MN/GK
15040
20 July 2015

**S.75W MODIFICATION TO HUNTLEE MAJOR PROJECT APPROVALMP_10_0137
HUNTLEE NEW TOWN**

Figure 1 – Proposed location of sub-stages to be amended

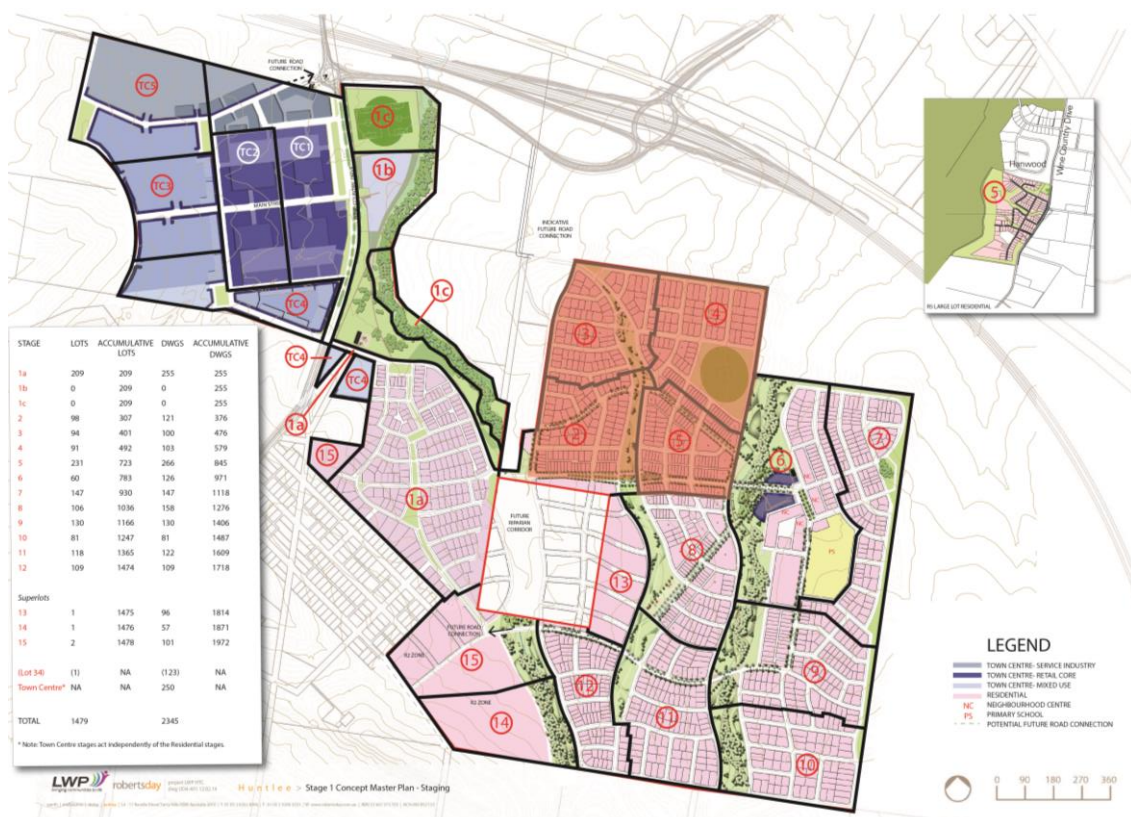
The modification proposes the reconfiguration of the sub-stage 2-5 residential lot layout as a result of the detailed subdivision design to improve the efficiency of road carriageways and increase access and permeability. The residential sub-stages 2-5 are identified on the *Stage 1 Sub-Stage Layout Plan* below in **Figure 1**.

Figure 2 – Proposed subdivision layout plan, Sub-stage 2-5

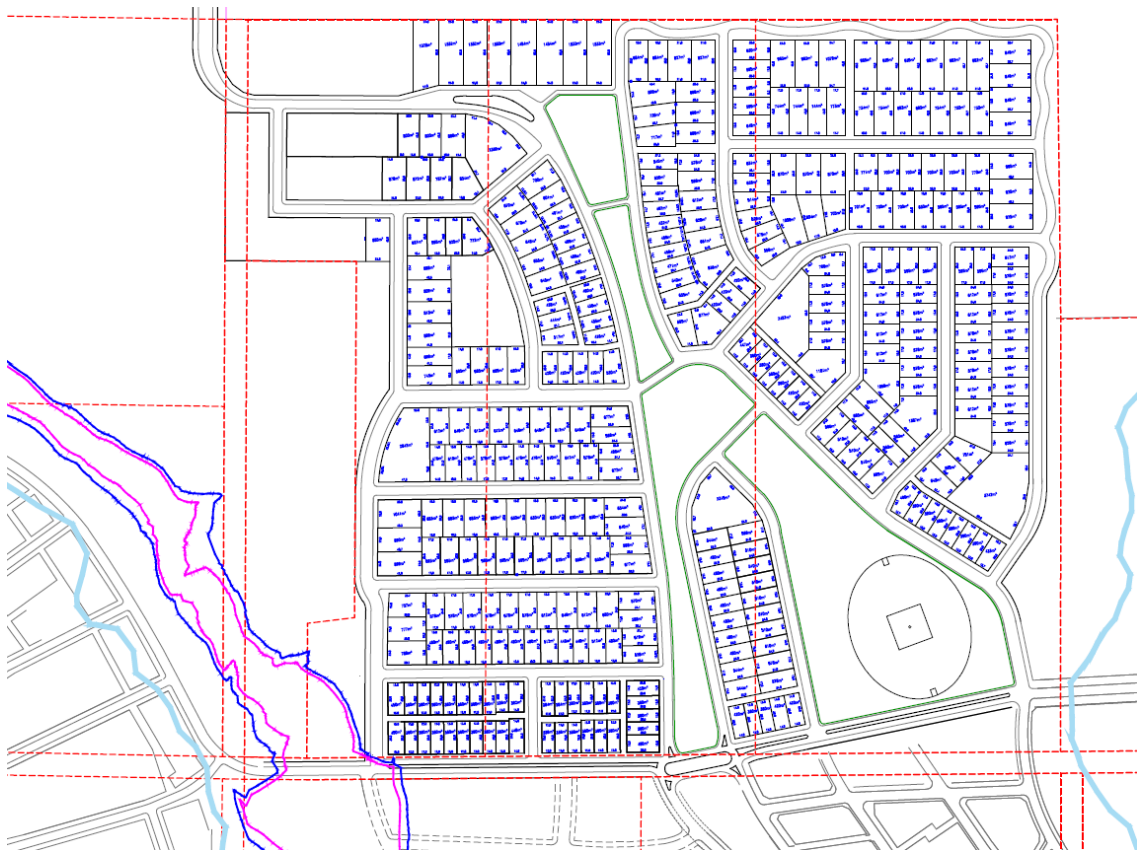
As previously stated, the reconfigured lot layout is a result of the detailed design of sub-stages 2-5. The modified lot layout is shown in **Figure 2** below and a site wide Masterplan is provided at **Attachment A**. The proposed lot layout improves the efficiency of the development by creating more linear street blocks and therefore reducing the required length of roads and improving the legibility and permeability between the residential sub-stages and the Central Ridgetop Park. The proposed subdivision design provides for more contiguous curved street blocks along the Central Ridgetop Park alignment to improve the residential and built form frontage to the Parkside Avenues at the park edges.

A lot layout plan has been prepared by Roberts Day (see **Figure 2**) and is provided at **Attachment A**. The plan demonstrates that the 100 Year Flood Extent and the Flood Planning Level (100 Year Extent +0.5m freeboard) will not encroach on any of the modified residential allotments. In addition to this, the modified lot layout will not have any significant impact on stormwater runoff as there are no stormwater detention basins located within sub-stages 2-5.

Figure 4 – Proposed lots to be modified within sub-stage 1
Source: Daly Smith

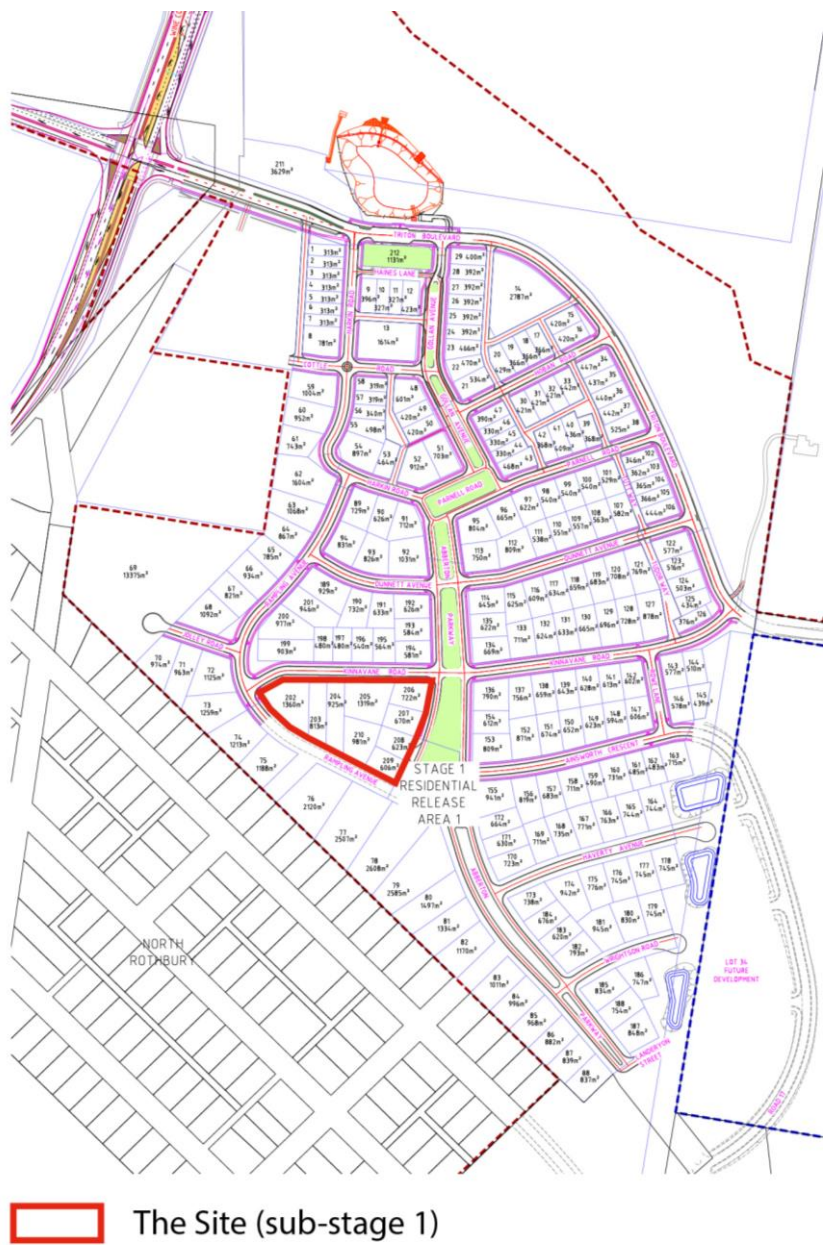
In addition to the reconfigured lot layout in sub-stage 2-5, the modification seeks to amend the layout of 7 lots within sub-stage 1. The sub-stage 1 lots proposed to be modified are identified below in **Figure 4**.

Detailed subdivision plans for the sub-stage 1 lots are provided at **Attachment F** and are also shown in the Site-wide Masterplan (**Attachment A**). The modified lot layout reduces the number of lots within the street block from 11 (approved) to 9 (proposed). The proposed lots are increased in size to provide a greater level of amenity and allow for future development that may include duplex homes or attached dwelling houses.

Figure 6 – Required Bushfire Asset Protection Zones
Source: RPS

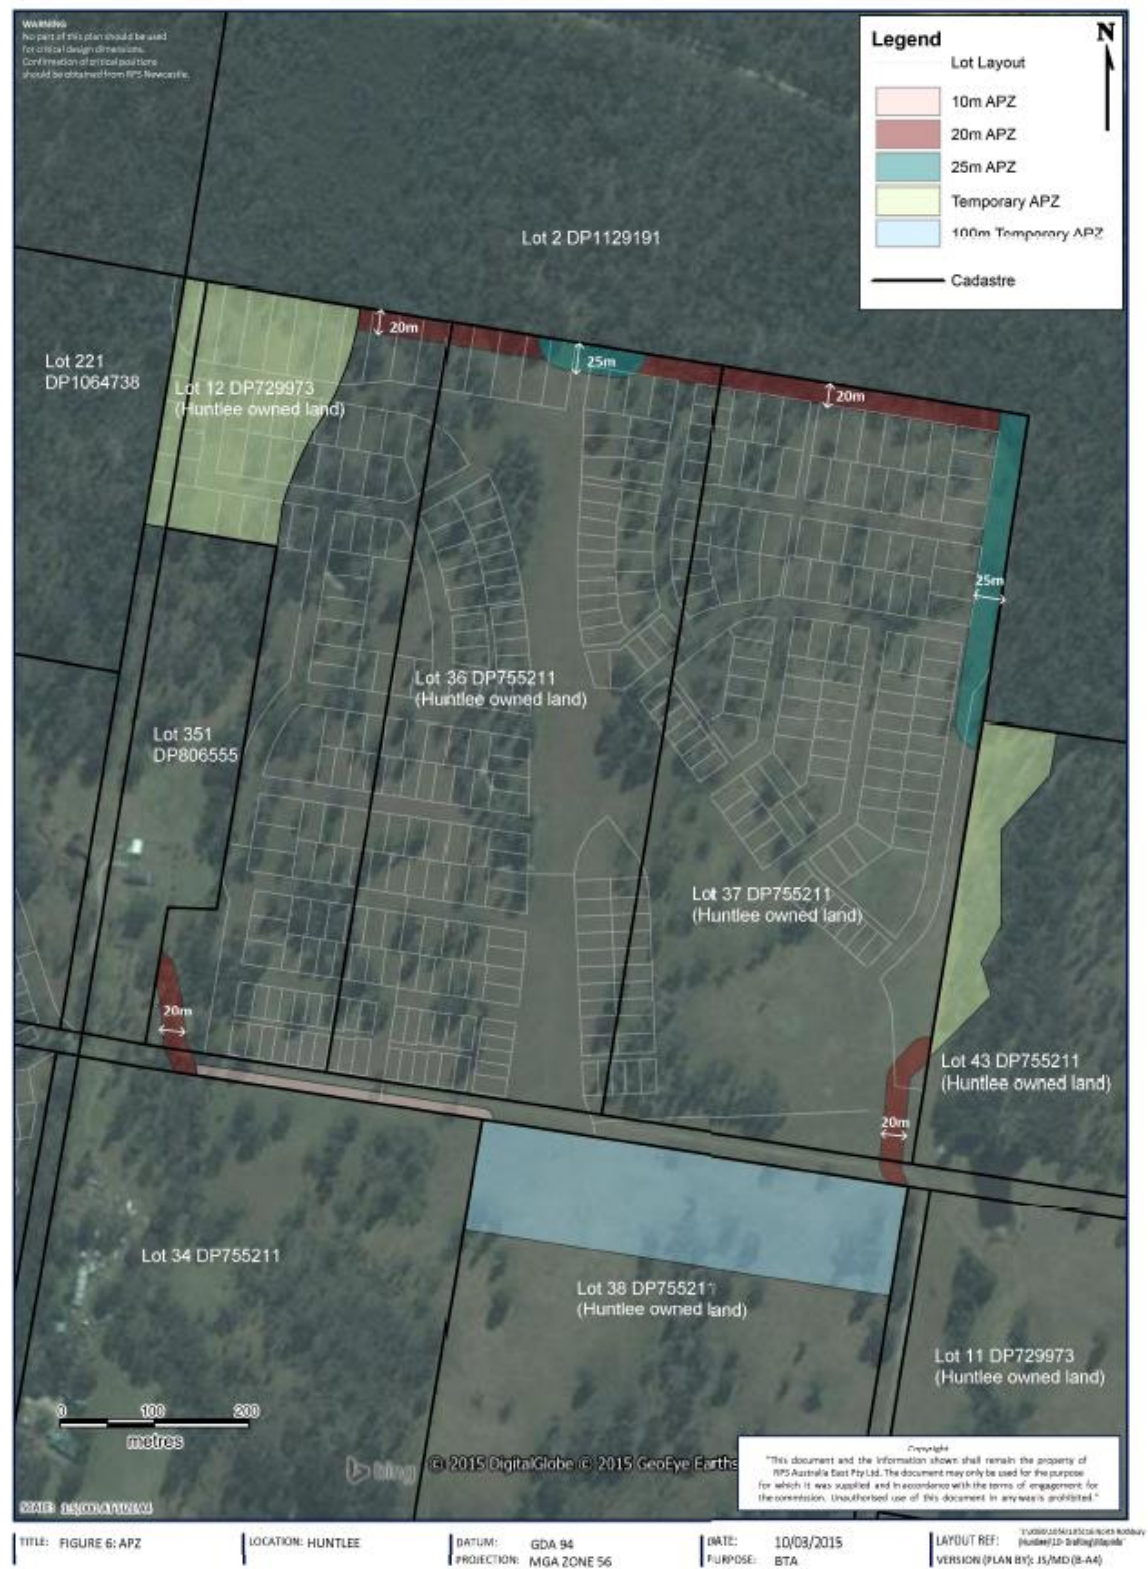
A Bushfire Threat Assessment Report (BTA) has been prepared by RPS and is provided at **Attachment D**. The BTA provides an assessment of the potential bushfire impacts on the sub-stage 2-5 residential allotments and access roads. The Assessment provides a slope assessment for a distance of 100m around the Site and an assessment of the surrounding vegetation and future land uses. The BTA provides that the site is located on bushfire prone land and contains Category 1 and 2 Vegetation as well as Vegetation Buffer lands. The Assessment recommends the implementation of Asset Protection Zones APZs and various other fire mitigation and control measures (see **Figure 5**) as outlined below:

- A 20 m wide Asset Protection Zones (APZ) is recommended to the north (in part) and east of the site between the hazards and proposed development. The APZ on the northern boundary

- A 25m APZ is recommended to the north (in part) and the north east of the site between the hazards and proposed development. This APZ will be accommodated within road carriageways and larger residential allotments;

- A 10m APZ is required between the hazard on Lot 34 and the site. This APZ is accommodated within the road carriageway;
- Temporary 100m APZs are required to the north west and south on Lot 38. This land will be subject to future urban development and as such will not pose a long term bushfire threat to the Site;
